Evaluation of the Proposal for Widening and Deepening the Matagorda Ship Channel

Scope of Current Study

Will a 2 ppt salinity change matter?

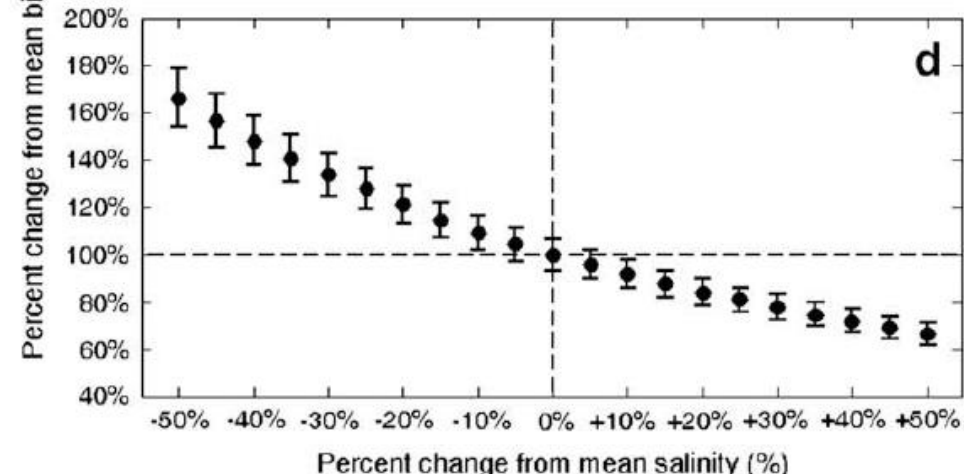
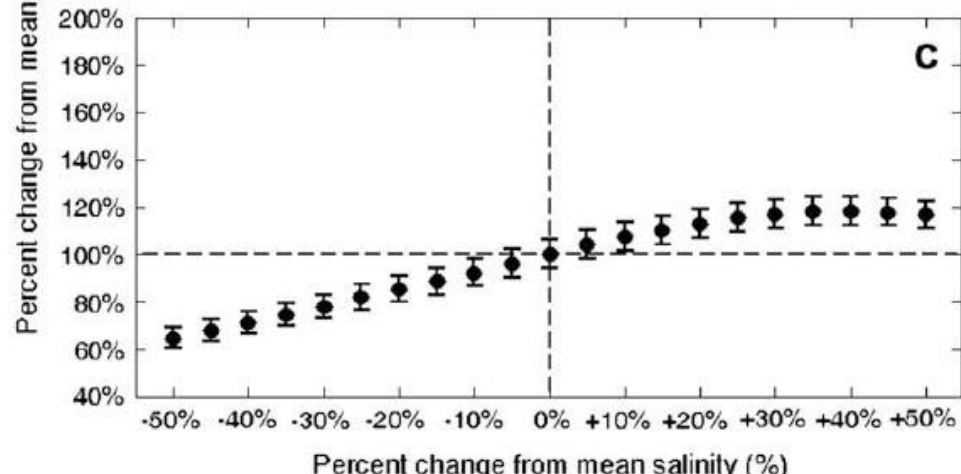
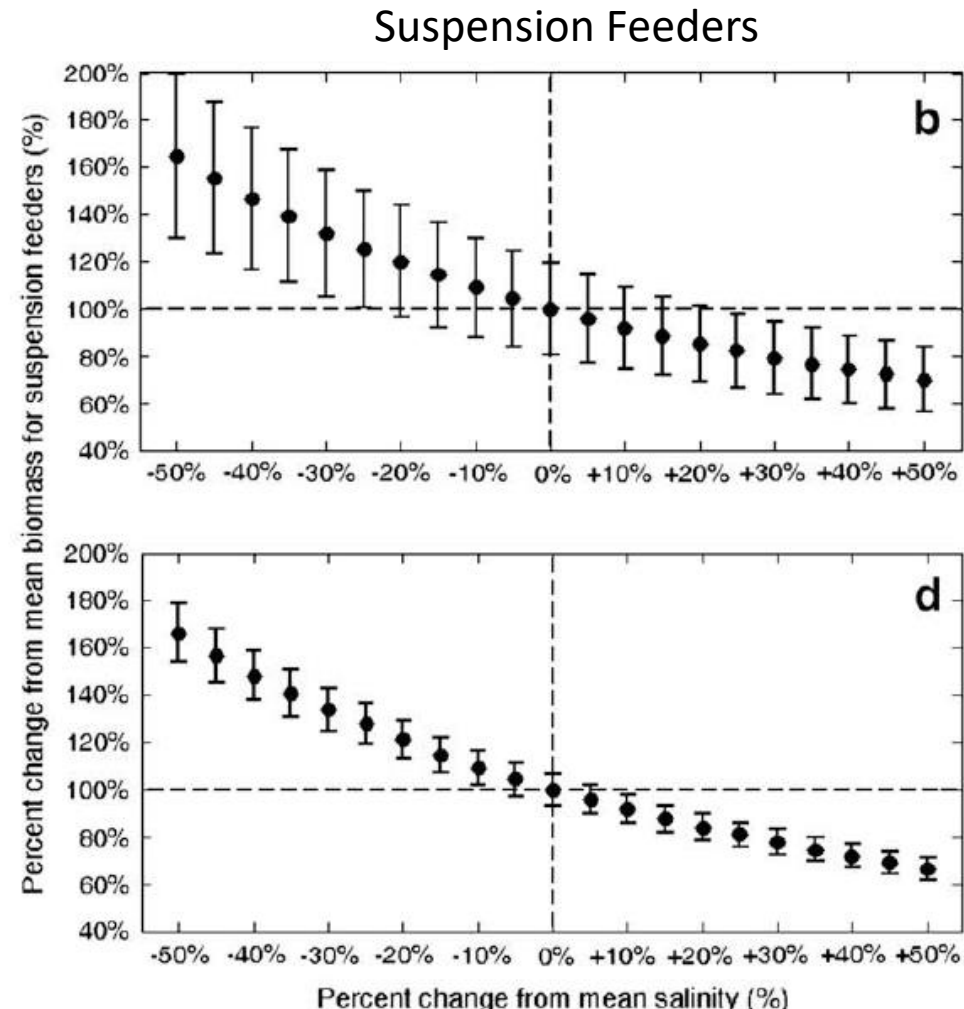
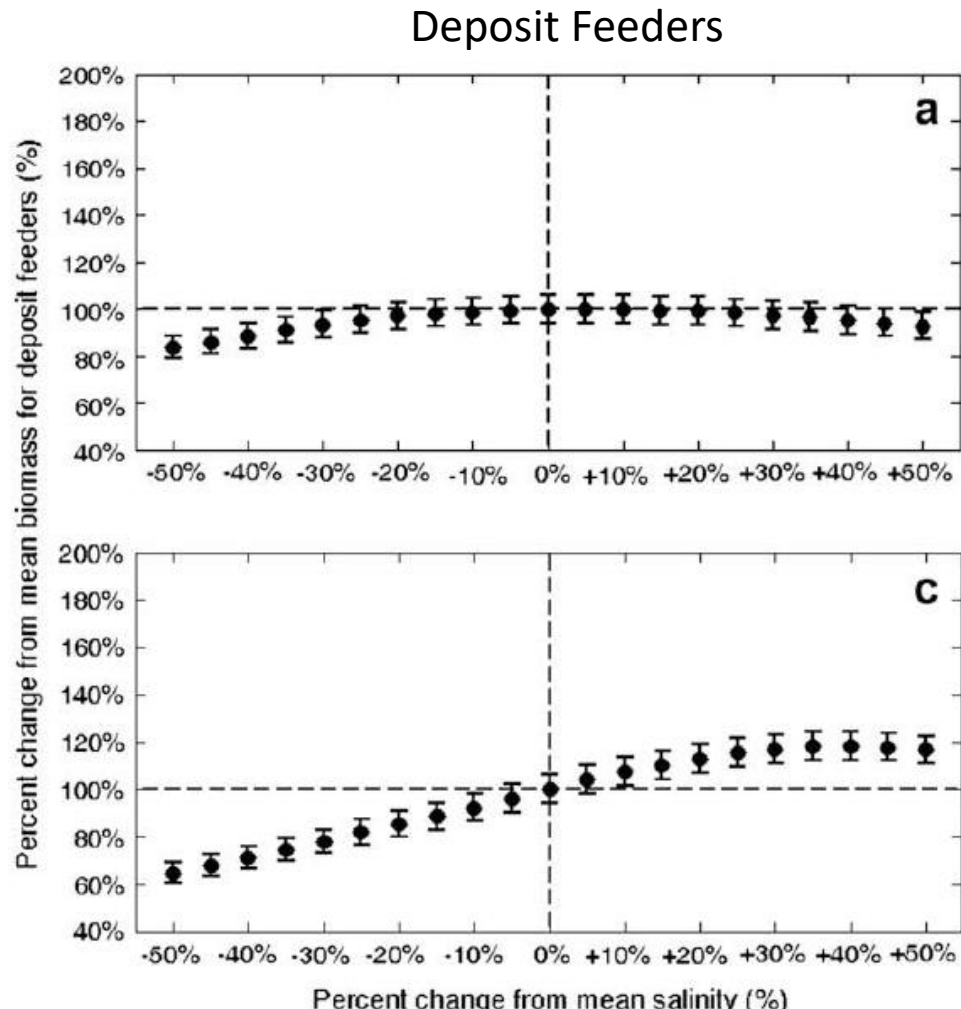
- Long-term average is 22, so that is a 10% change
- More worms, and fewer shellfish, but by only 5-10%

Oyster Reefs Near the Matagorda Ship Channel

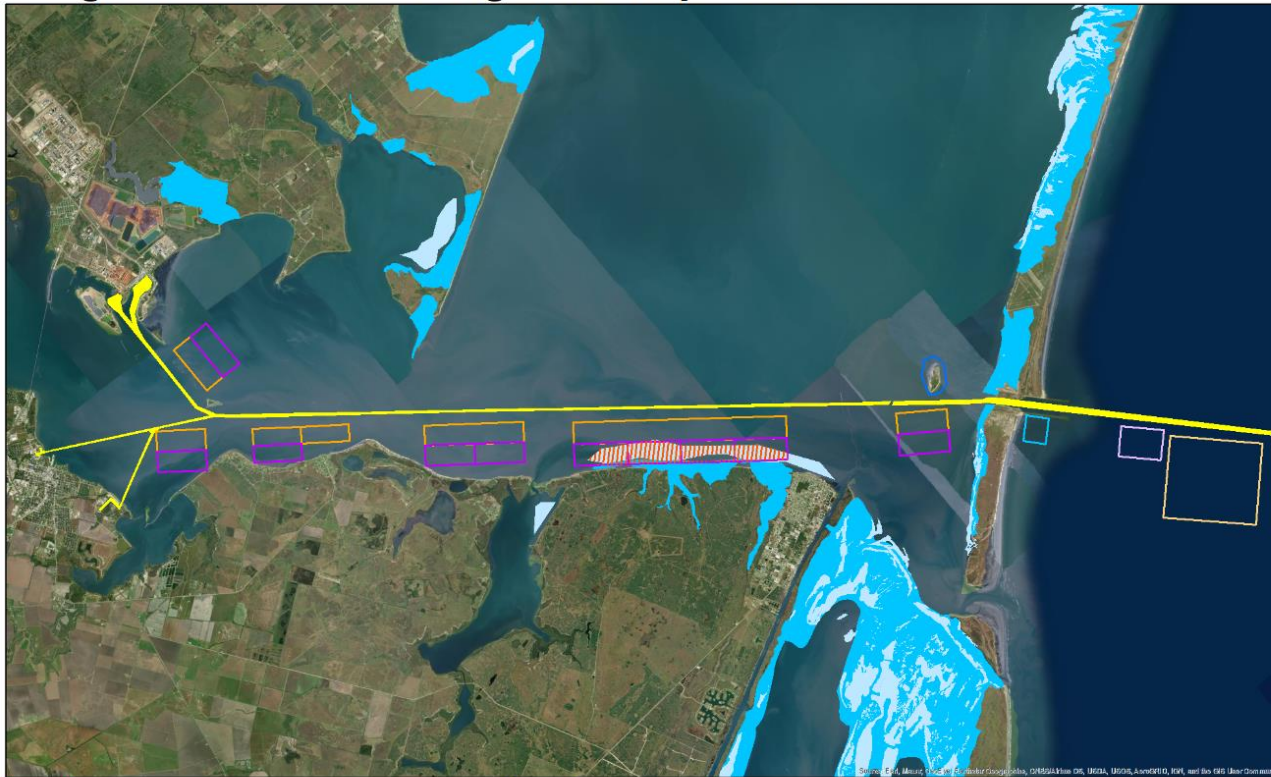
- 838.6 acres of oyster reef will be directly impacted by construction
- Mitigation plan says only 129 acres impacted and contains only 130 acres for mitigation

Seagrass Near the Matagorda Ship Channel

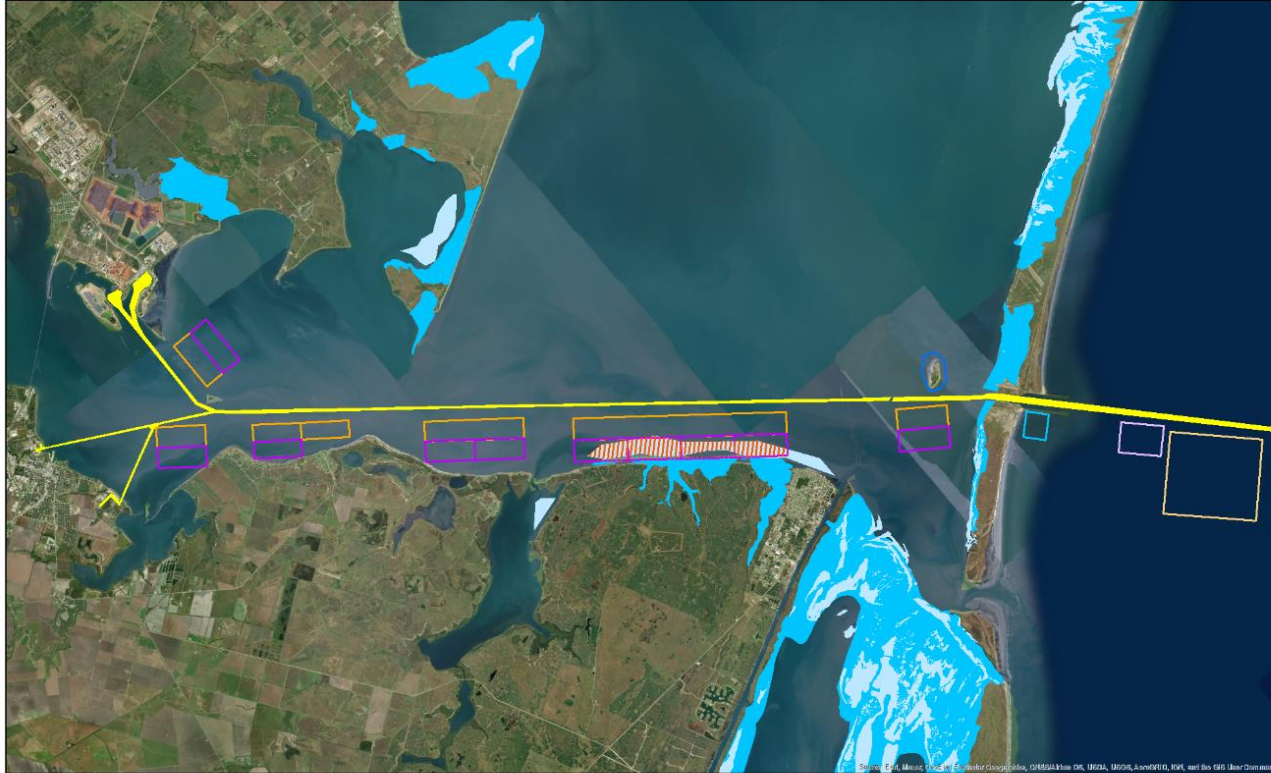
- Mitigation plan says 3927 ac will be impacted, no mitigation planned.
- Benthic communities typically recover within one year
